**Application by East Anglia One North Limited for the East Anglia ONE North Offshore Wind Farm Development Consent Order.**

**Application by East Anglia TWO Limited for the East Anglia TWO Offshore Wind Farm Development Consent Order.**

#### **DEADLINE 5 RESPONSE**

This letter contains the Deadline 5 response in respect of both of the above proposals from EDF Energy Nuclear Generation Limited ("**NGL**"). NGL is the owner and operator of the nearby Sizewell B nuclear power station ("**SZB**").

Extent of 300m buffer zone around  
**SZB cooling infrastructure**  
 - - - 300m buffer SZB cooling infrastructure

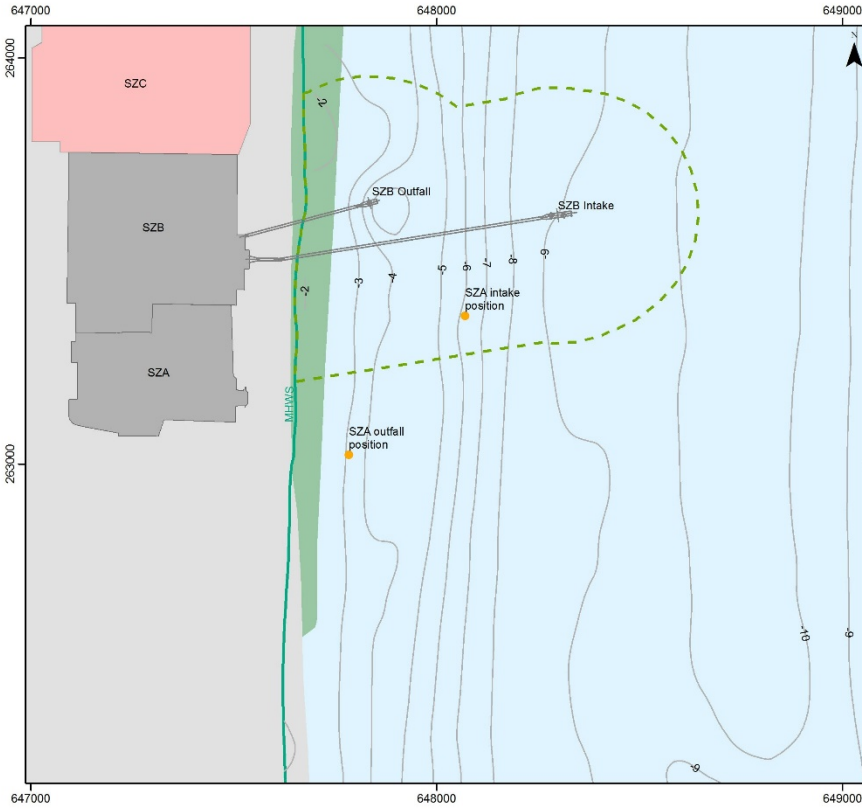
5. —(1) No part of the works for the authorised project shall take place using vessels allied with those works within a buffer zone extending 300 metres from the Sizewell B cooling water intake and outfall and associated seabed culverts (as shown on drawing MS0359A) nor shall any anchor be placed within or chains or cables laid across that buffer zone during the course of such works unless the undertaker obtains the prior approval of EDF Energy (not to be unreasonably withheld or delayed) to the placement of such anchor or chains or cables within the buffer zone.

(2) The relevant centre point positions for the 300 metre buffer zone are—
